JAGUAR

05.1-16

TECHNICAL BULLETIN

Poor Hot Start – Tank Pressure Control Valve – Check Operation

ILLUSTRATION 1

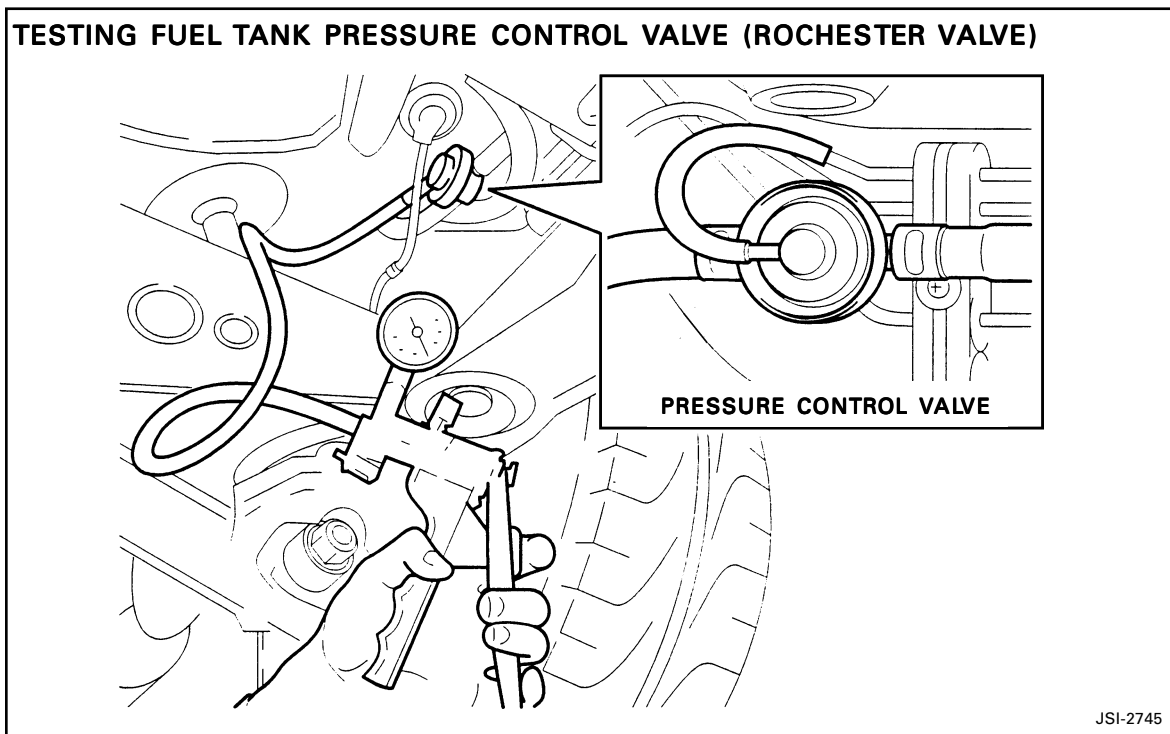
2. Disconnect the vacuum hose (Illustration 1) from the control valve.

3. Connect a vacuum tester to the pressure control valve fitting (Illustration 1).

4. Apply a vacuum of **2.94-14.7 in. Hg. (0.1-0.5 bar)**. If this vacuum cannot be held **for 2-3 seconds**, the valve is faulty.
